**Re: NMOCD Case No. 15442: Application of BC Operating, Inc. for
Authorization to Inject, Eddy County, New Mexico**

From: Holm, Anchor [mailto:aholm@slo.state.nm.us]
Sent: Thursday, March 17, 2016 9:55 AM
To: Goetze, Phillip, EMNRD <Phillip.Goetze@state.nm.us>
Cc: Martin, Ed <emartin@slo.state.nm.us>; Warnell, Terry G. <twarnell@slo.state.nm.us>
Subject: BC Operating - Grande State #1 SWD Proposed Plugback

APPLICATION FOR AUTHORIZATION TO INJECT

WELL NAME & NUMBER: GRANDE STATE #1 API 30-015-31910

WELBORE SCHEMATIC

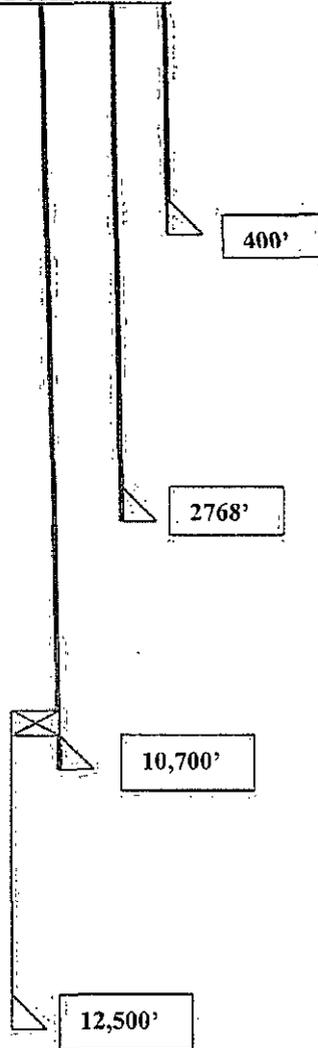
Yesterday, I received the revised copy of the C-108 SWD Application for the Grande State #1 (30-015-31910) by BC Operating. Their Proposed SWD interval is from 2,780' to 4,900'. In this wellbore the bottom of salt was recorded at a depth of **2600'**, which must be protected from solution by disposed produced waters. Typically, a minimum buffer of at least 300 feet is desired by the State Land Office in order to protect the surface Trust Lands from potential subsidence caused by salt water disposal.

Therefore, the State Land Office recommends that the top of injection be lowered to a depth of **at least 2,900'**. Also, in the well located on the same lease about ½ mile east of the proposed SWD, the bottom of salt was reported at 2,775'. This suggests that a **top of injection of 3,075'** may be more prudent.

An additional concern is the construction of the Grande State #1 wellbore. It did not have the annulus outside the 7" casing cemented above 5,650'. The 9-7/8" surface casing was set at 2,768', only a short distance below the bottom of Salt reported in the subject wellbore. However, the offset well having a top of salt reported at 2,775', which is deeper than the surface casing setting depth in the Grande State #1 wellbore.

Therefore, the State Land Office recommends that the proposed cement squeeze of this annulus be modified from a target top of cement at a depth of 2,266' to a requirement to **circulate cement to surface**. The reasoning is that the cement job at the shoe of the surface casings in this area frequently do not fully protect the salt from being dissolved by SWD operations. By placing additional hydraulic head on the surface casing shoe during the squeeze cement job, the strength of the seal at the shoe will be significantly improved.

3-1/2" OD, Internally Plastic Coated Tubing set @ ~~2,750'~~ **3280'**

~~2,780' to 4,900' (Perforated)~~
3380' 4400'
